AGENDA ITEM- 620-271

Title: Shaping of Plates

Purpose: To explain clearly meaning of Table in 6.4 of API-620 (Agenda 620-251)and how to apply.

Tank Diameter
Figure- 6.2
Shaping of Plates (Para. 6.4)
Aluminum Tanks

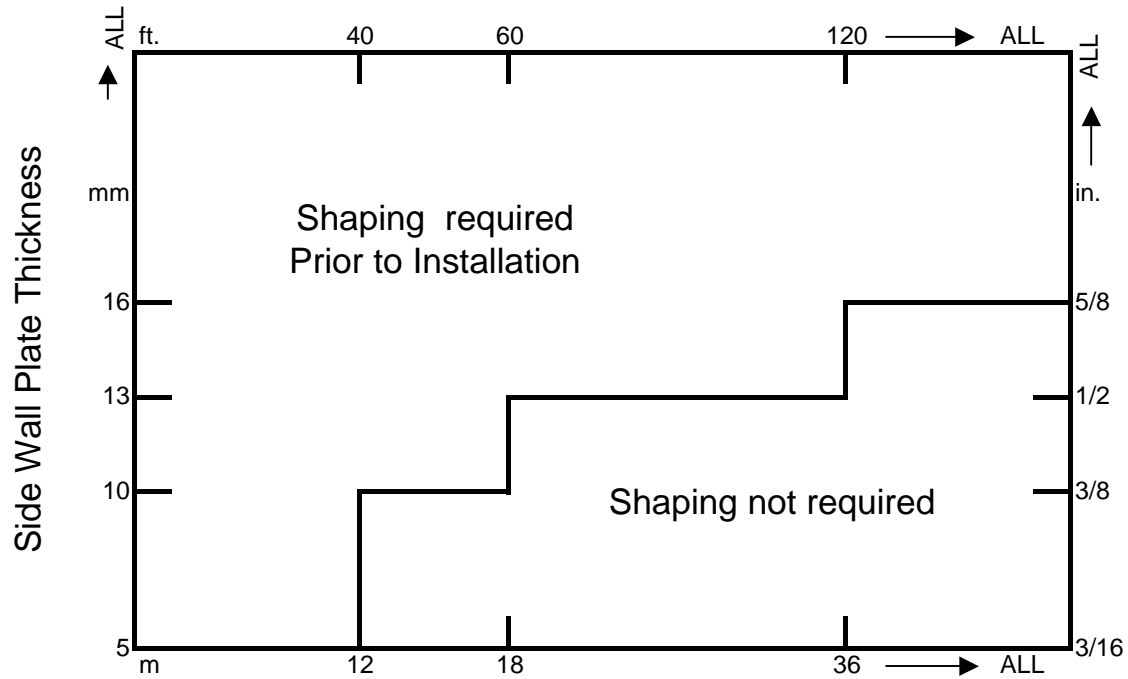
Figure 6.1 for steel tanks and Figure 6.2 for Aluminum tanks provide criteria for shaping of cylindrical sidewalls to the curvature of the tank prior to installation in the tank. Shaping of plates concurrently with installation in the tank shell is permitted if the diameter exceeds the limits in the Figure 6.1 (for steel tanks) and Figure 6.2 (for Aluminum tanks) or if the manufacturer's alternate procedure for any diameter has been accepted by the purchaser.

Note: Any combination of diameter and thickness falling on or above the solid line requires shaping prior to installation.

Tank Diameter
Figure- 6.1
Shaping of Plates (Para. 6.4)
Steel Steel Tanks

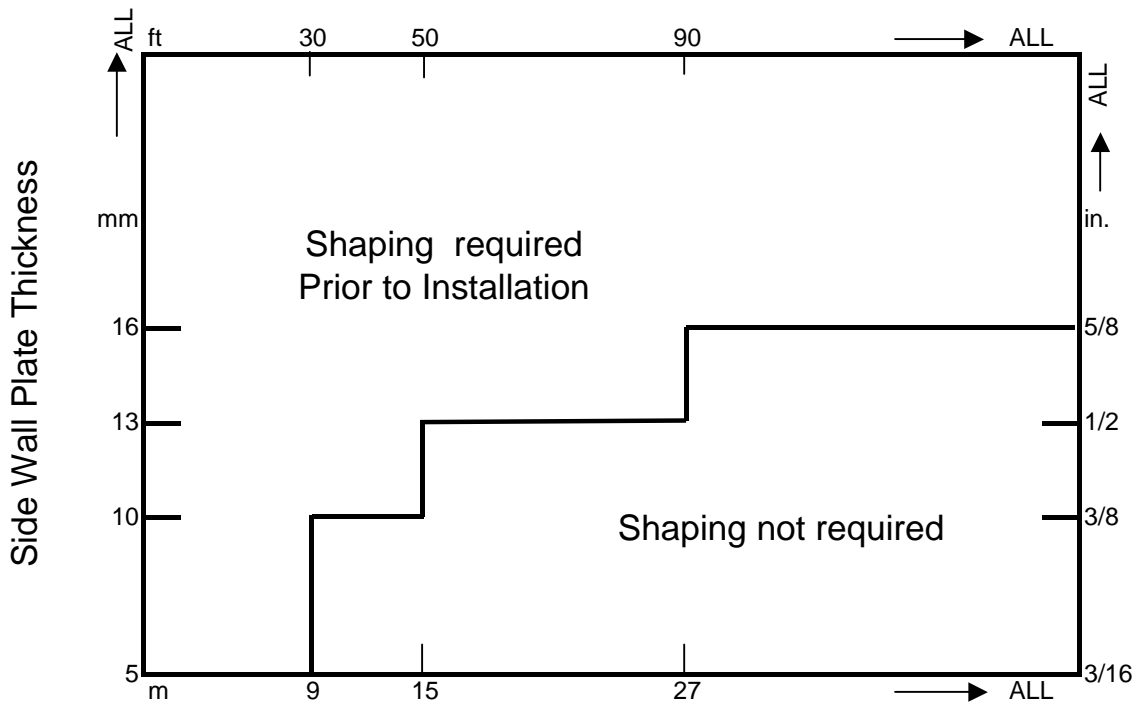
6.4.1 Cylindrical Side Wall Sections:

Note: Any combination of diameter and thickness falling on or above the solid line requires shaping prior to installation.
